PROJECT	Downeast Correctional Facility 19176	DATE SENT	8/28/2020
SUBJECT	ADDENDUM 2-DCF Men's Reentry	ADDENDUM ID	ADD-02-DCF MRC
		TRANSMITTAL ID	00049
PURPOSE	For Bid	VIA	Info Exchange

DESCRIPTION: Please find attached Addendum #2. This addendum forms a part of the bidding and contract documents and contains additional Security drawings.

Addendum 02

To	David Schoenherr	Date	August 28, 2020
For	Downeast Correctional Facility – Men's Reentry Center	Project No.	19176-01

SCALE: AS NOTED
PROJECT MANAGER: JGJ PROJECT NO: 19176
A/E OF RECORD: DJT
JOB CAPTAIN: CBM
DRAWN BY: TAR
SMRT FILE: TY104-19176 SHEET No. TY104

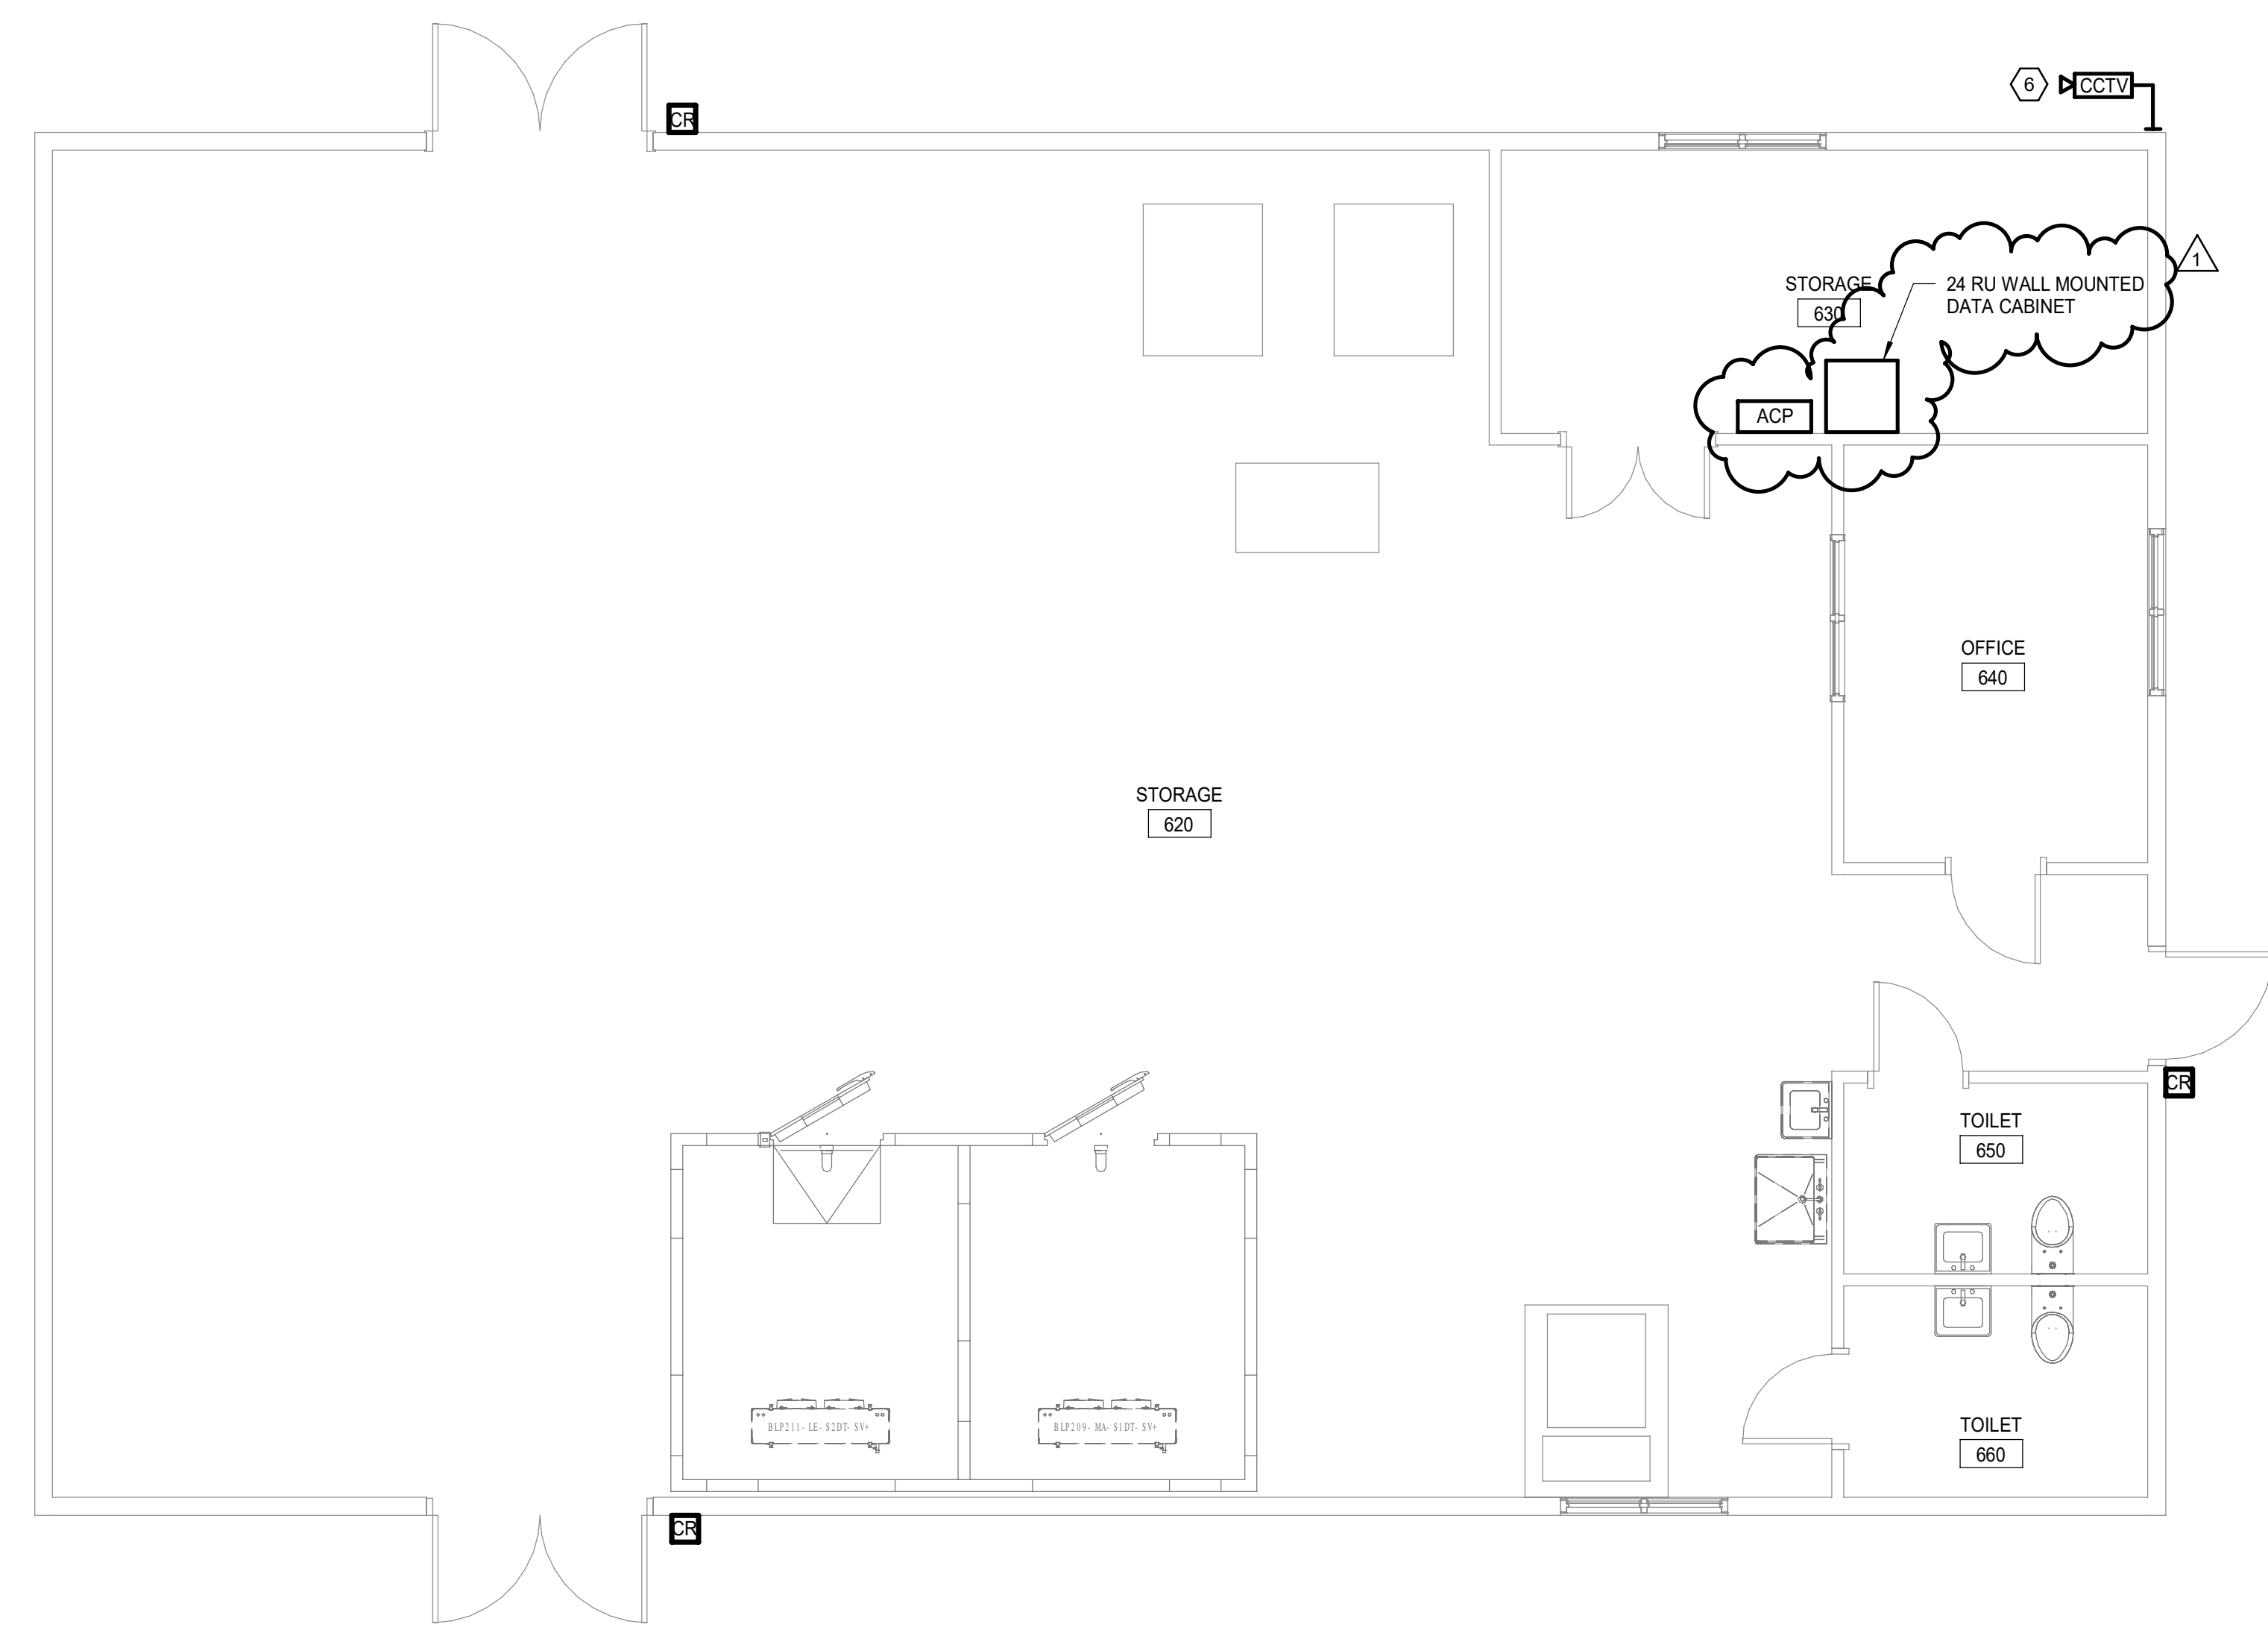
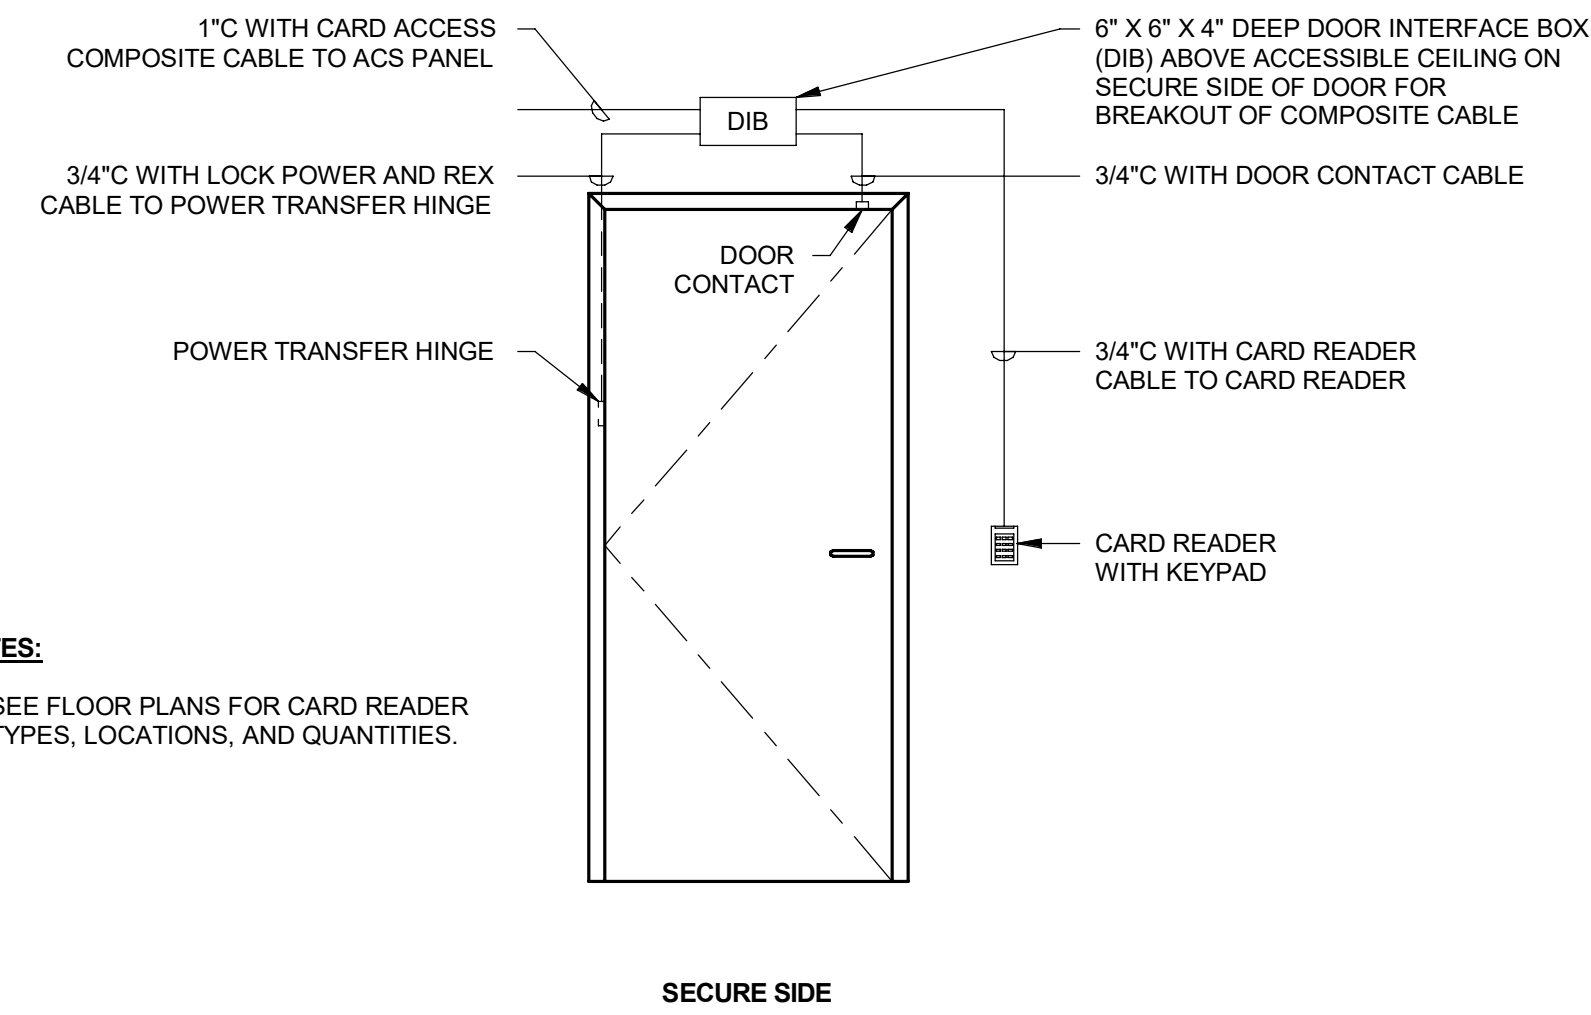
1. New Drawing **TY104** – Technology Plan. Exterior Camera information. Card reader/Door security information. 24 RU Data cabinet & ACP
2. New Drawing **TY651** – Technology Single line diagram.
